Item 7.22 - Drawings

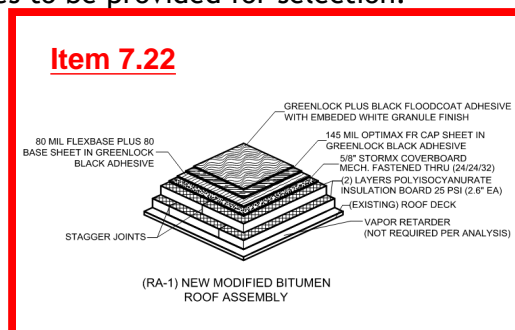
1. Vapor retarder membrane is missing from New Modified Bitumen Roof Assembly. Per SOW, this VR membrane must be included until both validated by a completed/approved Hygrothermal analysis and removed from the contract requirements through Bid Option.
2. Greenlock plus black floodcoat is noted in assembly information, but Pyramic Plus LO is submitted for a flood coat application. Please clarify the use of the products and clear the conflicts. See more comments in item 7.17. **1. ASSEMBLY IN THE SHOP DRAWINGS HAS BEEN UPDATED TO SHOW THE V/R, LISTED AS NOT REQUIRED.**
2. PYRAMIC PLUS LO IS FOR VERTICAL FLASHINGS ONLY. GREENLOCK PLUS BLACK WILL BE USED FOR THE FLOODCOAT.

- 3. NOTED N/A** 3. Any fasteners used for insulation board or cover board attachment shall be verified with Vapor Retarder manufacturer for acceptability and self-gasketing ability within system (unless VR membrane is removed from Contract). Any missed or improperly placed fasteners shall not be backed out of the vapor retarder, subsequently creating perforations in the material reducing performance metrics.

- 4. NOTED** 4. Contractor to ensure sufficient overlap of edge metal with existing wall panels/fascias. Some details appear to barely extend to existing finish. Larger edge metal vertical faces shall be provided where needed to sufficiently overlap.

- 5. SEE RESPONSE** 5. Detail 3/R-2, is manufacturer accepting of this condition? Would it make more sense to extend flashing plies onto the steel channel and provide a termination bar just beneath the existing metal flashing with treated joints/seams to ensure a higher termination point?

- SEE REVISED SHOP DWGS (ITEMS 6-9)** 6. Detail 5/R-2, please clarify that this is for premanufactured curbs only, and that a separate detail applies to lumber-constructed curbs with roof membrane extending up and over curb. Please verify that the curbs this detail applies to have premanufactured flashing or other water control methodology, or provide new drip flashing with backdam at these curbs to avoid water intrusion.

7. Detail 1/R-4 and 2/R-4, please clarify in detail that ice dam membrane is being provided full length onto existing wall substrate IAW UFC 3-110-03, 5-4.1.1.2. Detail is unclear on termination point of underlayment.

8. Detail 3/R-4 and 4/R-4, please indicate underlayment extending as high as possible behind headwall/sidewall flashing.
9. Where are snow retention devices? See SOW 2.14.23.1.17 and UFC 3-110-03, 5-2.10.1. Please provide locations and details.

10. Please provide fabrication details and mounting details for roof ladder replacements. **10. SEE DWG**
- 11. SEE REVISED SHOP DWG G-3** 11. Missing tapered insulation and cricket plans/shop drawings. Please provide.

12. Clarify fastener pattern locations and intended fastener.

12. APPROVED FASTENERS

APPROVED PLATES
